**AMENDMENT 5**

**Invitation for Bid (IFB)  
UOG IFB No. B23-01**

UOG INVITATION FOR BIDS NO. B23-01:  
MULTI-STEP SEAL BID FOR CONSTRUCTION SERVICES

**QUESTION & ANSWER SHEET NO. 3**  
**July 25, 2023**

## 2EP102

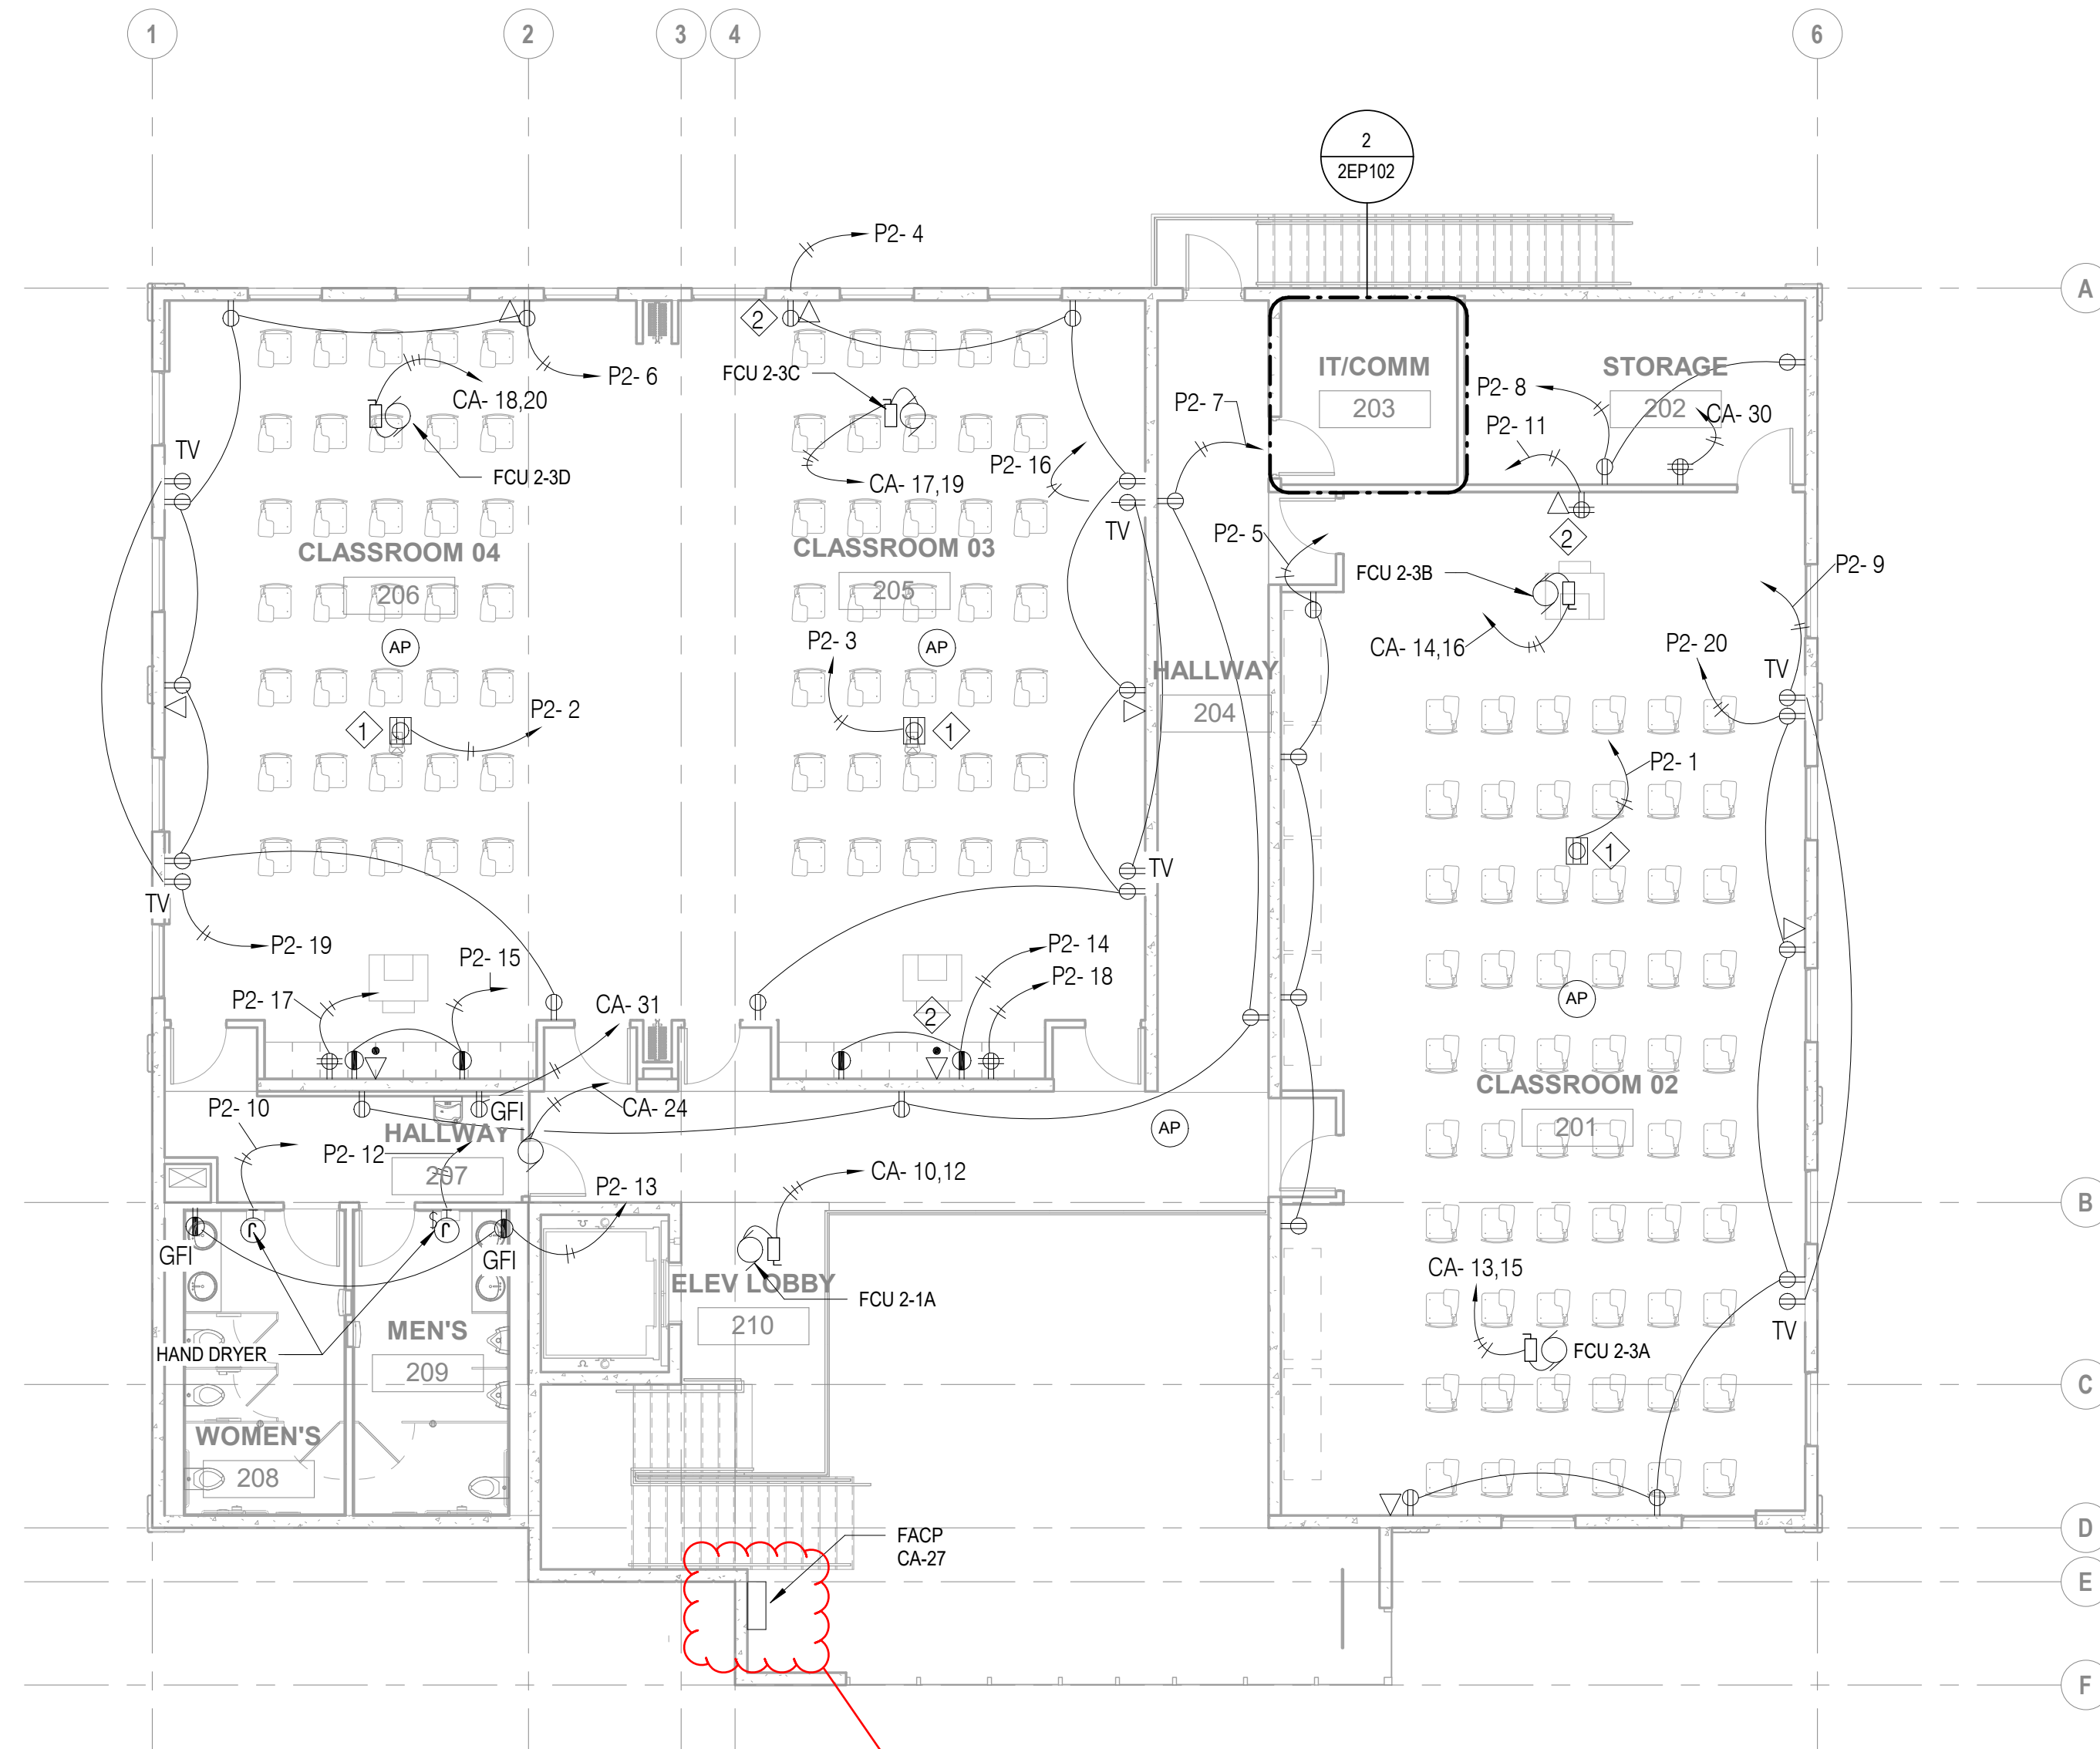
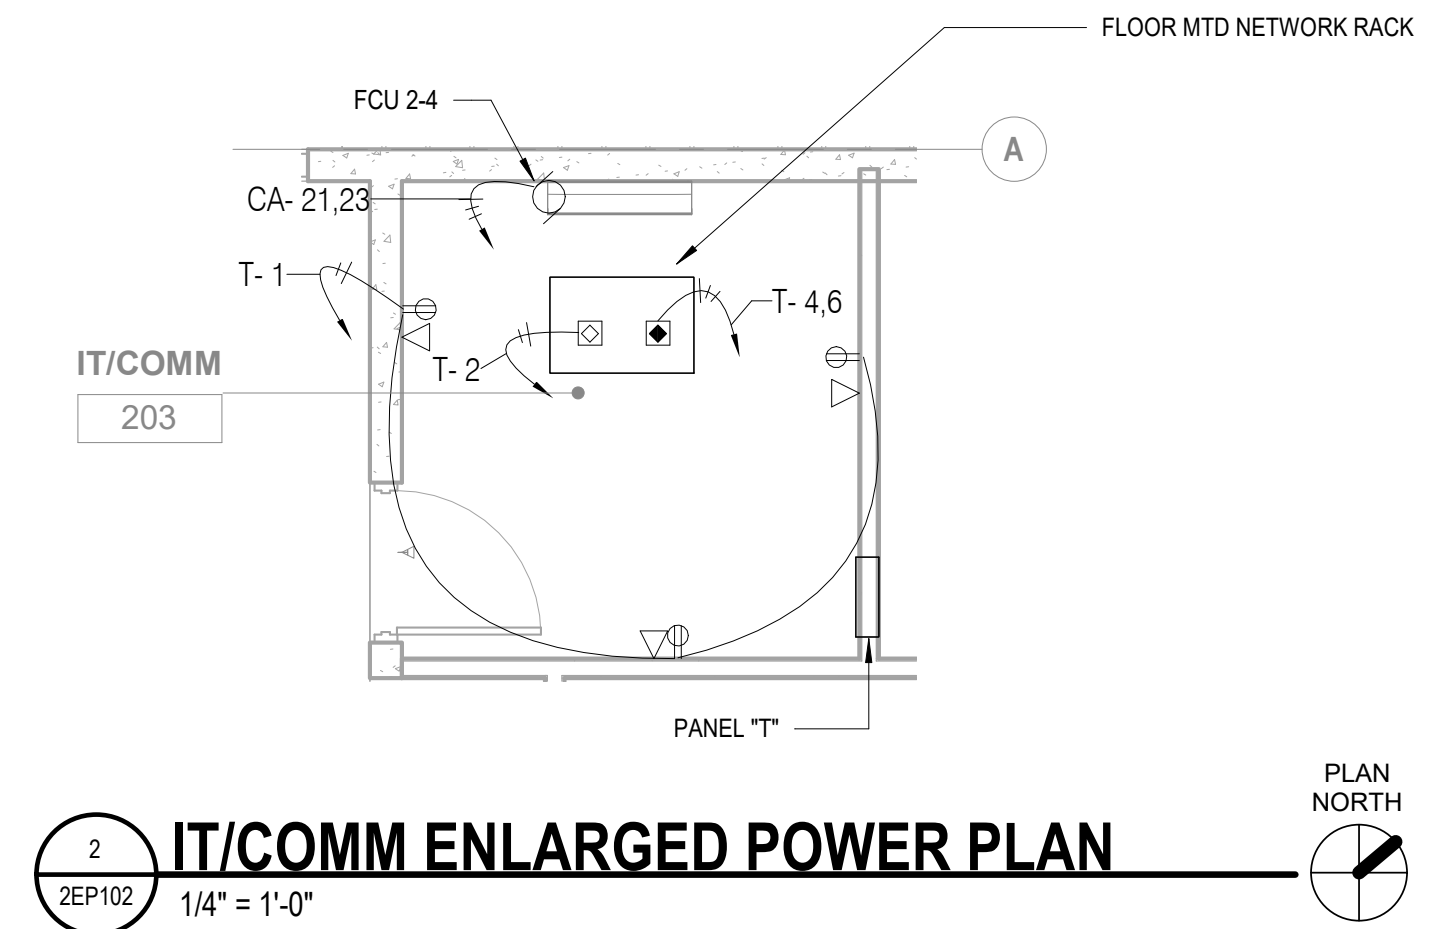
Please confirm if this will be provided by GC. Kindly provide the dimension / specifications if not.  
\*FACP is part of the bid package, see specifications

**1 ONE-LINE DIAGRAM**  
NTS

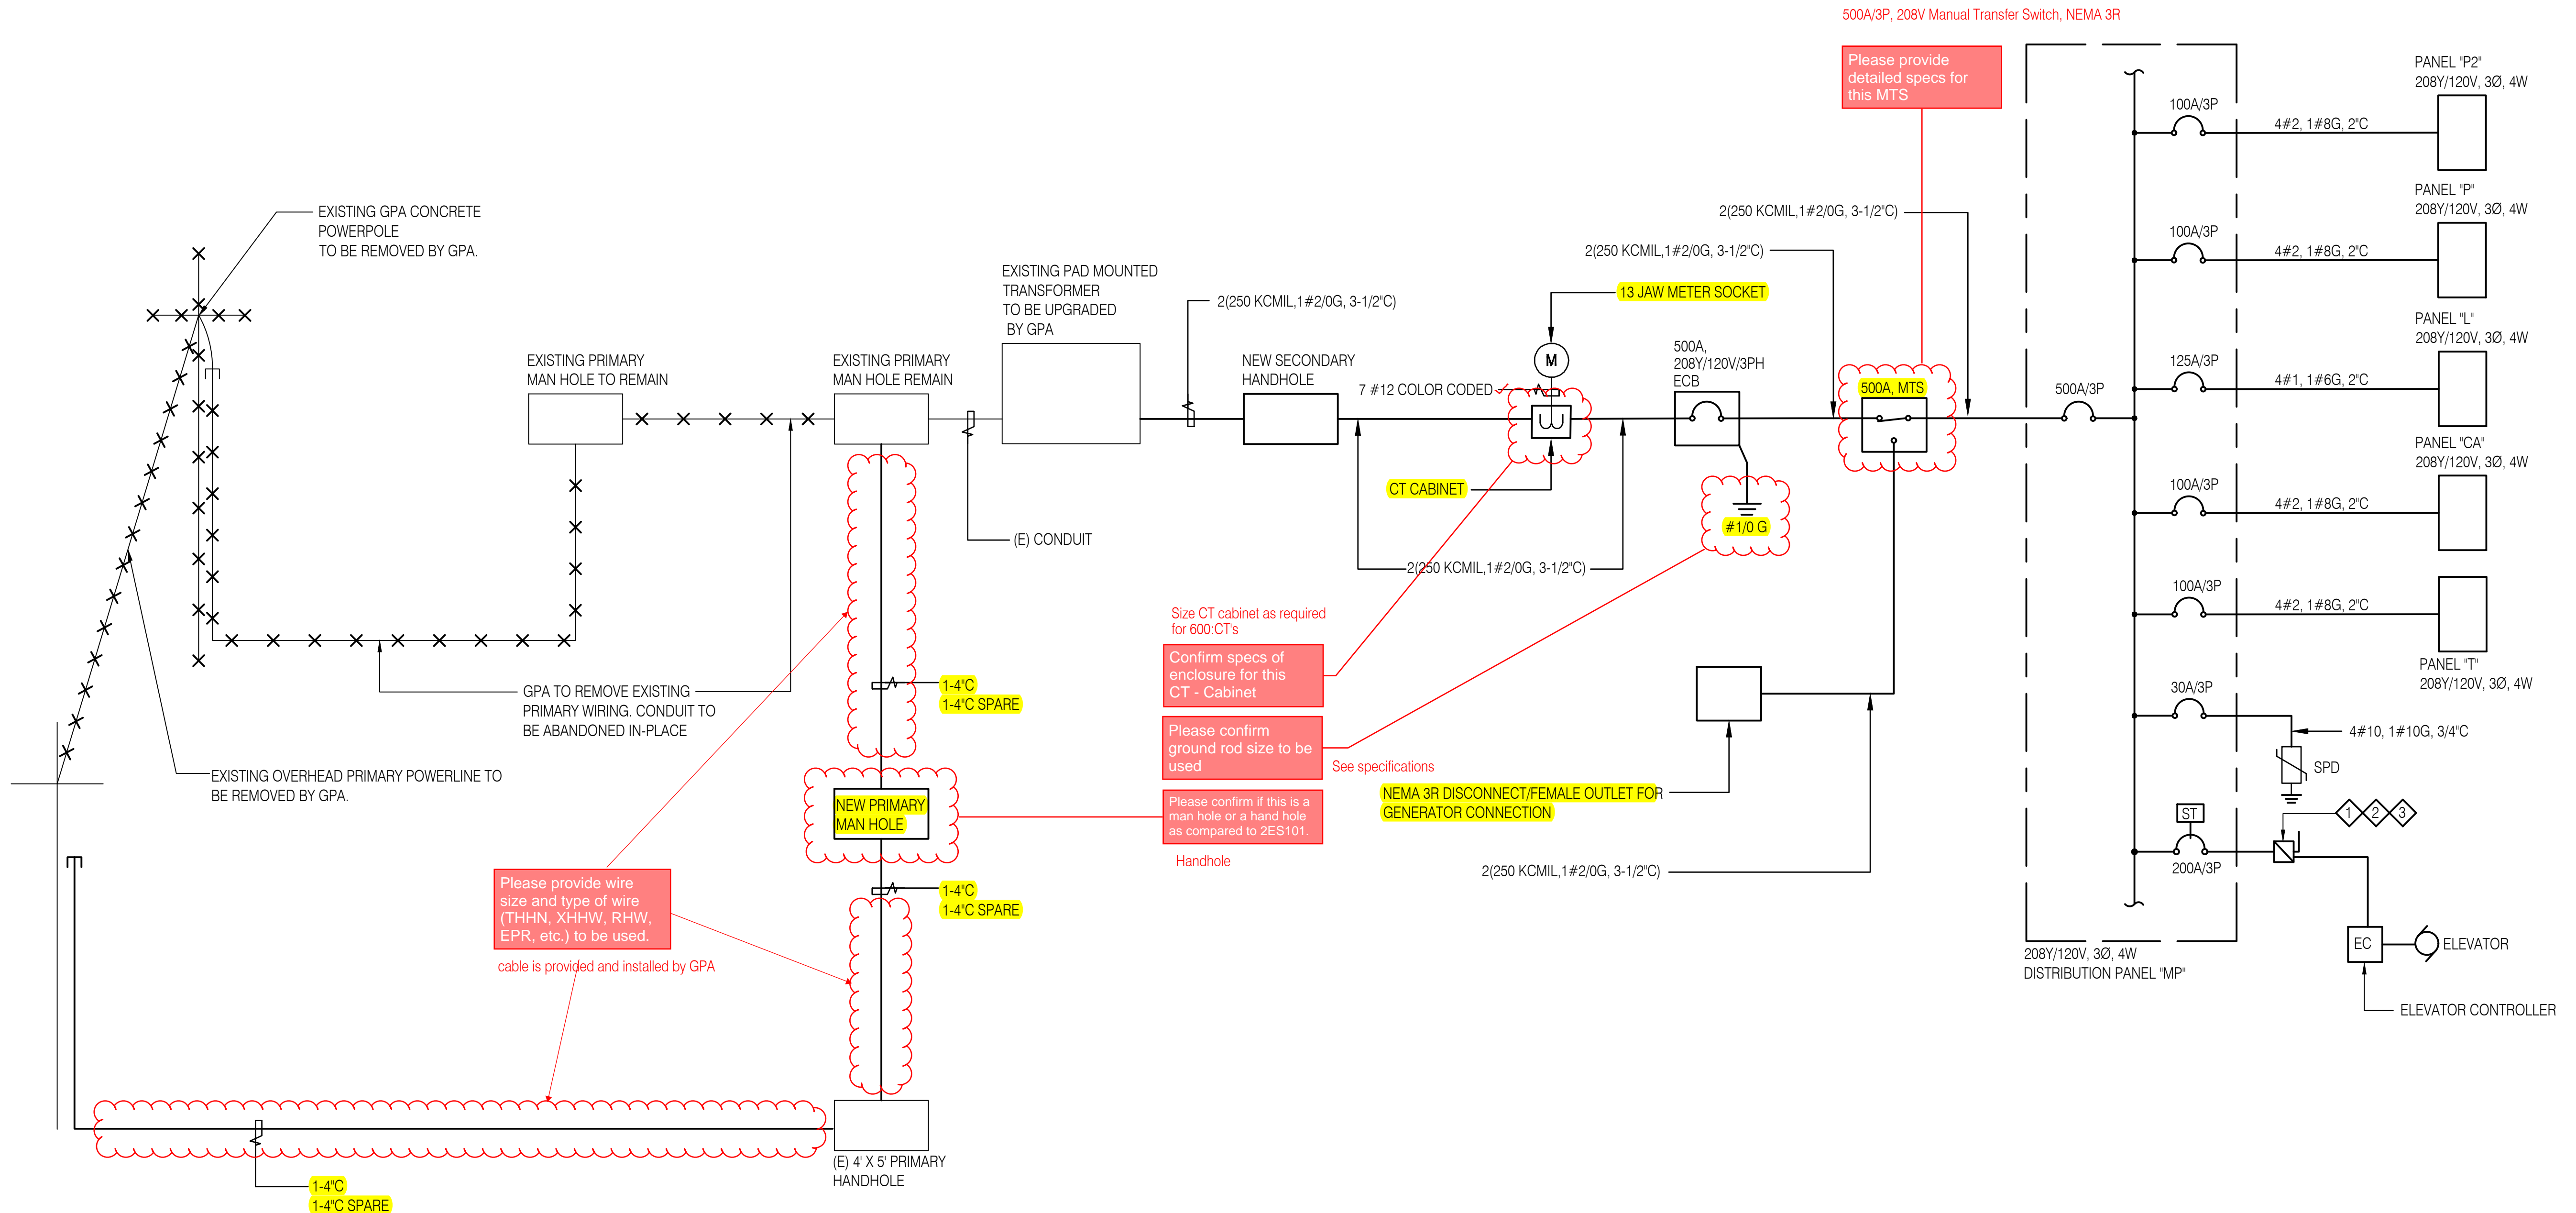
500A/3P, 208V Manual Transfer Switch, NEMA 3R

Please provide detailed specs for this MTS

Size CT cabinet as required for 600:CTs

Confirm specs of enclosure for this CT - Cabinet

Please provide wire size and type of wire (THHN, XHHW, RHW, EPR, etc.) to be used.

cable is provided and installed by GPA
